Appl. No. 09/851,471  
Amdt. Dated August 21, 2006  
Reply to Office Action of March 7, 2006

**Amendments to the Drawings:**

FIG. 1  
PRIOR ART

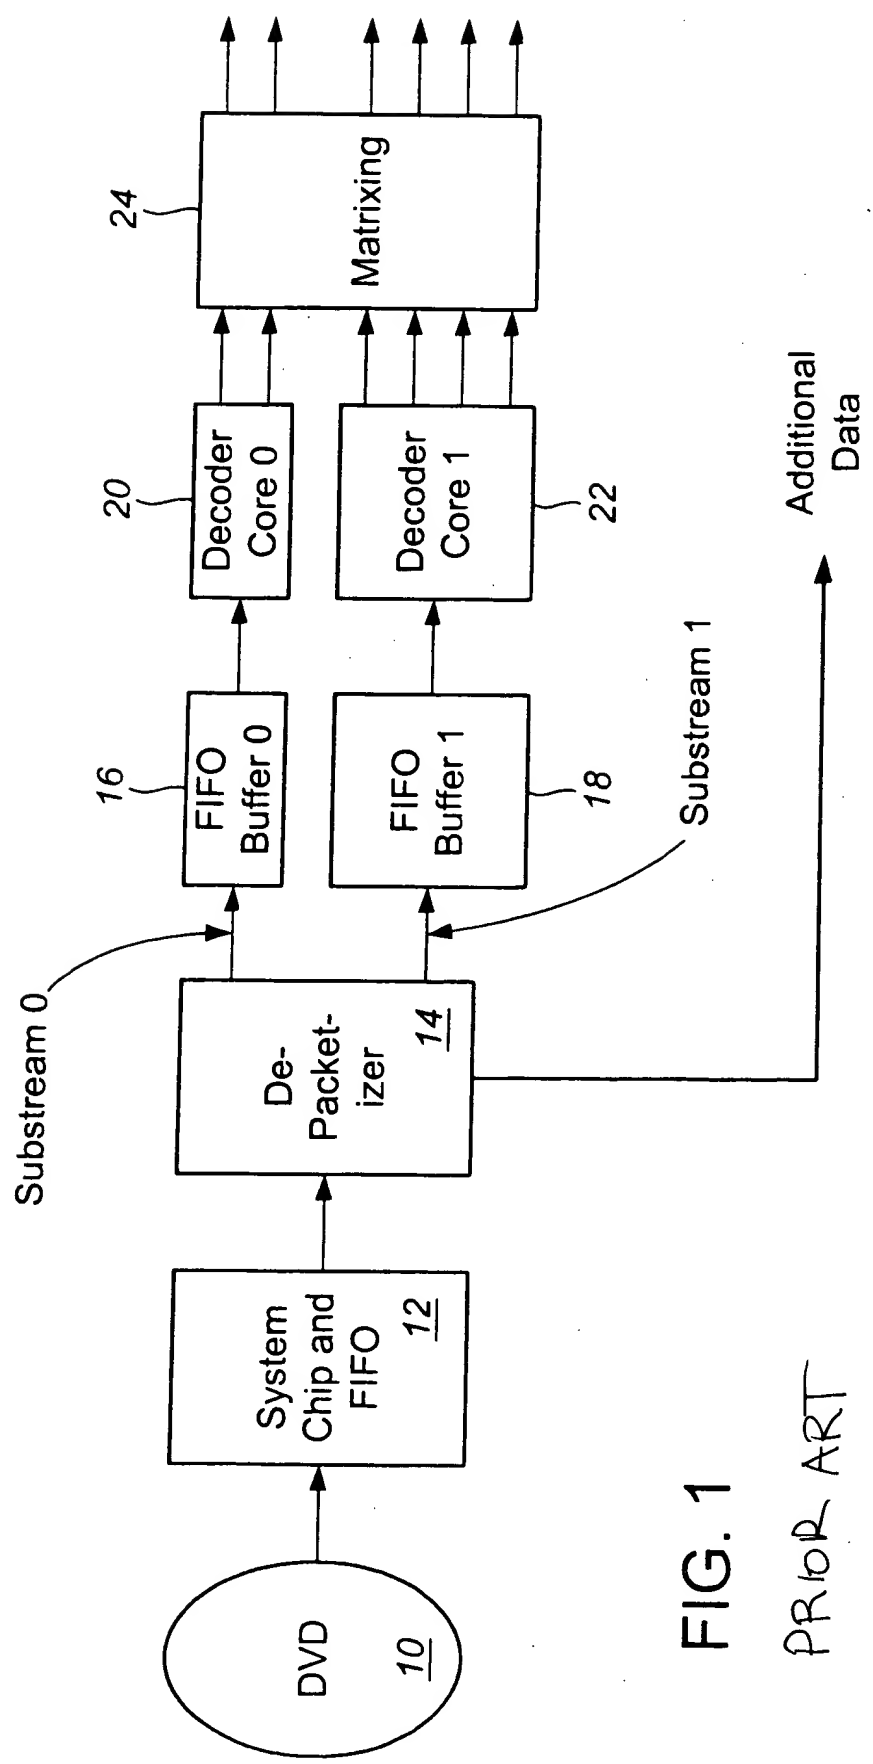
The attached sheets of drawings includes changes to FIGS. 1-3. These sheets replace the original sheets including FIGS. 1-3. The legend "Prior Art" has been added to FIGS. 1-3.
